Building Permit Review Comments Response Letter:

Re: **Staff Report DSRFY2023 - 0006**
Starbucks
5586 N Maple Grove Rd. Garden City, Idaho 83714

Below is a list of responses to review comments for Starbucks Garden City, each followed by relevant details and actions taken.

A-1.0

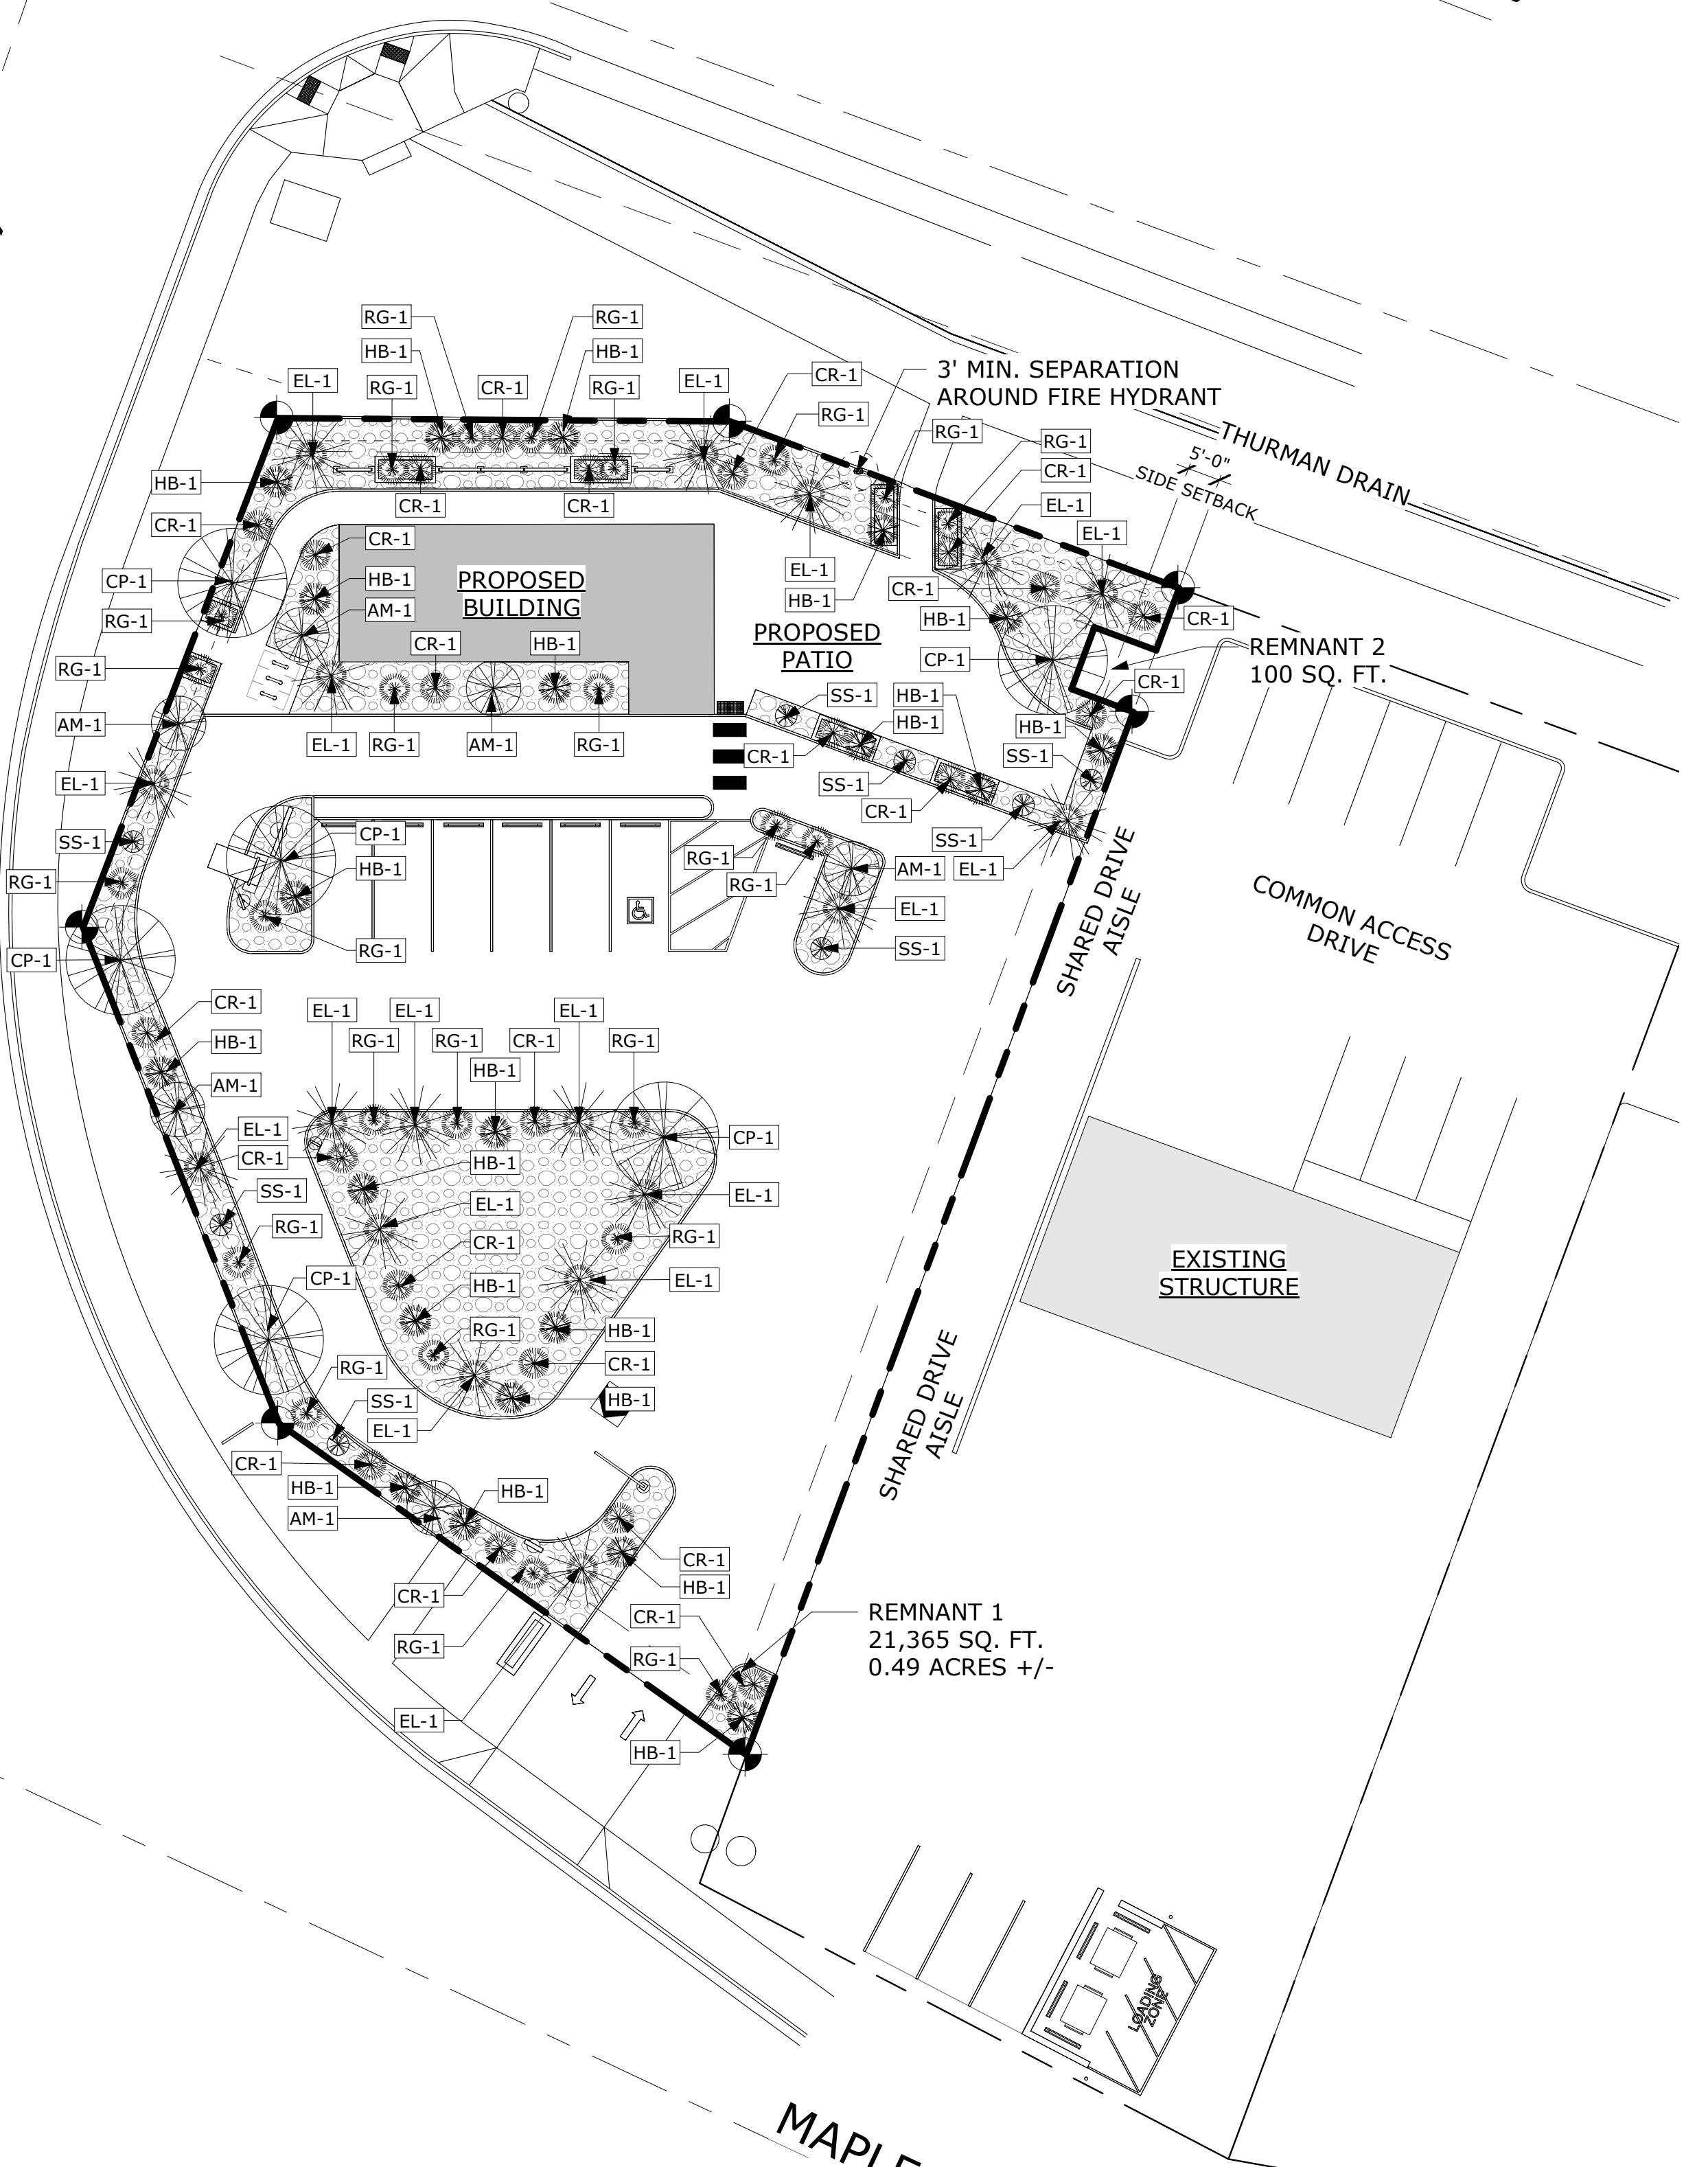
1. **8-2B-3** - The property does not appear to meet the minimum street frontage, refer to 8-4C discussion and analysis.
R1. Please see sheet A-1.0 for updated building orientation, which is proposed to meet the minimum street frontage requirements by utilizing the building's façade, as well as a plaza.

2. **8-2C-13** - Stacking study has not been provided.
R2. Please see keynote 23 for the stacking study on sheet A-1.0.
3. **8-2C-13** - The stacking lane and drive through window are oriented toward the front setback along Maple Grove.
R3. Please see updates to sheet A-1.0 which reflects proposed changes to the drive thru orientation.

4. **8-2C-13** - Pedestrian walk up window faces internal to the development, adjacent to the parking lot and pedestrian plaza area. The building does not provide in structure seating area, as it is a drive thru only.
R4. Please see updates to sheet A-1.0 which reflects proposed changes to pedestrian access to the site, changing the main point of access from Chinden to Maple Grove in order to route pedestrian traffic out of the way of the drive thru.

5. **8-2C-13** - It is unclear how wide the pathways are
R5. Please see updates to sheet A-1.0 which shows minimum sidewalk widths are 5', in accordance with the ADA.

6. **8-2C-13** - Both pedestrian pathways from the existing and proposed sidewalks will intercept with the drive aisles of the project. It appears that painted stripes are indicating pedestrian crossings. Signage indicating crossing has not been shown on site plans.
R6. Please see updates to sheet A-1.0 which reflect changes to the pedestrian circulation throughout the site. Also, see keynote 22 for location of pedestrian crossing signage.

7. **8-2C-13** - Not provided, the stacking lane is longer than 100'
R7. Please see keynote 20 on sheet A-1.0 which show changes made to include an escape lane.

8. **8-2C-13** - Not compliant, restroom has not been provided for patrons.
R8. Please see keynote 24 which indicates the entrance for the proposed public restroom.

9. **8-2C-13** - To reduce vehicle emissions, signage shall be provided advising drivers to reduce vehicle idling.

1. **8-4A-5** - The trash enclosure details have not been provided. It is unclear what the trash enclosure is made of, and what the gate looks like. It is visible from both Maple Grove and Chinden.
R1. See keynote 1 on sheet A-1.0 for details.

2. **8-4A-5** - It is unclear how far the trash enclosure is from the property boundary lines.
R2. See updated dimensions on sheet A-1.0.
3. **8-4C-3** - The structure does not appear to meet the street frontage requirement. 60% of the street frontage along the front setback should be occupied by a structure or plaza. The property has two streets to address, N. Maple Grove and W. Chinden Blvd. most of the site consists of landscaping and hardscaping, the structure makes up for a small percentage of the site. To meet the street frontage requirement, the structure would need to be within 5- 20' of the property boundary line, which is considered the "frontage zone". Or a plaza can be placed in-between the right-of-way and the structure to count towards the 60% requirement and increase interaction with the public ROW. A pedestrian plaza is provided; however, it is internal to the development and does not address either street. It is unclear, but it does not appear the building provides the minimum 15% glazing along the facades facing the streets. There might be blank walls.

4. **8-4C-3** - Not enough information to review. It appears that the driveway width at Maple Grove is larger than 20'.
R4. Please see updated dimensions on sheet A-1.0. The aforementioned driveway is existing; however, we have updated our site to reflect requirements set forth in Ordinance 1034-22.

1. Bicycle parking spaces shall: Be a minimum space six feet (6') long by two feet (2') wide. Not enough information.
R1. Please see updated dimensions on sheet A-1.0.
2. **8-4D-7** - Off street loading zone is not defined in the submitted plans. Clarification is needed. If a loading zone is provided, the above standards shall be met.
R2. An on-site parking and drive aisles are proposed to have a dual purpose and act as a loading zone. Please see keynote 21 on sheet A-1.0 as a reference.

1. **8-4E-6** - This pathway is required on the subject property with a public access easement. The easement has been drafted as a condition for approval.
R1. Please see pathway shown on sheet A-1.0. See keynote 14 for the Thurman Drain fall protection rail, in accordance with Alternate 1 for the Chinden Blvd. South Sidewalk Project.

R9. See keynote 16 on sheet A-1.0 for location of idle-free signage, signage is to comply with city guidelines.

R3. Please see updates on sheet A-1.0, which show proposed changes to the building's orientation, and the site design, bringing the building to the frontage of the property, and providing a public plaza along the frontage as well. Refer to keynote 2 on the drawing titled PATIO (1/A-4.0), which references glazing on the frontage. Keynote 4 on the drawing title WALK up (2/A-4.1), also references glazing along the building's frontage. See general note F on sheets 4.0 and 4.1 for frontage glazing calculations.
